SERVICE LETTER 120 PAGE 1 of 4 REV: A

SERVICE LETTER NUMBER 120			
TITLE: Bushing repair for forward, lower center fuselage bow tie mounting plate			
BY: KMT	ACFT MAKE/MODEL(S):	FLOAT MODEL(S):	NOTE(S):
APP: KMT	Viking DHC6 -100, -200	13000	Optional compliance
DATE: 12-Apr-11	and -300		for repair purposes.
REV: A

SERVCE LETTER P/N: 1005290 for ECN 10076

Fig. 1 – P/N 13A02078-002, bow tie attachment plate, as removed from aircraft

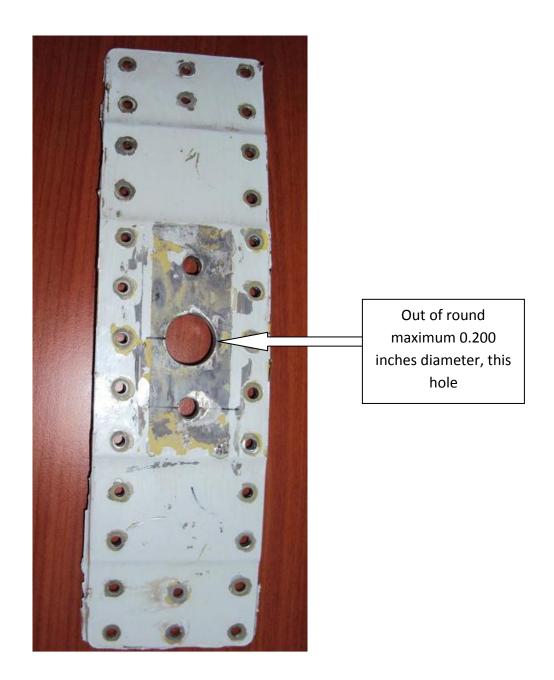
Certain Viking DHC-6-100, -200, and -300 aircraft have exhibited slight bearing wear on part number (P/N) 13A02078-002, bow tie mounting plate. This plate is riveted to the fuselage skin at the center lower forward jury strut mount. The center hole in this part receives the boss on P/N 13A02469-01. This boss is used to carry shear loads and may be slightly deformed or worn for high-time float equipped airframes.

- g. The maximum out of round that can be repaired with this SL is a 0.20 inch diameter out of round. I.e. the maximum diameter measured may be 1.20 inches.
- 3. Fabricate a repair bushing part as follows:
 - a. Material 2024-T3 aluminum per AMS QQ-A-250/4 or AMS 4037
 - b. Outside diameter 1.250 +.002 -.000 inches
 - c. Inside diameter ID 1.000 +.002 -.001
 - d. Thickness 0.25 to 0.27 inches
 - e. Break sharp edges to R0.015
 - f. Finish: bare part will be assembled wet
 - g. Dimensional tolerances are tight for the bushing interference fit. Slowly grind bushing to proper dimensions to ensure a good fit.
- 4. Remove P/N 13A02078-002 from the aircraft belly skin by drilling the attaching rivets.

Note: this repair cannot be accomplished while the attachment plate is installed on the aircraft, because it would not be possible to ream the attachment plate hole without potentially damaging the aircraft belly skin and interior fitting.
- 5. Ream the D1.0 inch hole on P/N 13A02078-002 to D1.250 +.000 -.001. Ensure the hole is reamed on center with the existing hole.
- 6. With the hole reamed, new bushing manufactured, and all dimensions double checked: press fit (at room temperature) the replacement bushing into the reamed hole. The bushing should be press fit wet with Mastinox or zinc chromate or epoxy primer for corrosion protection and sealing.
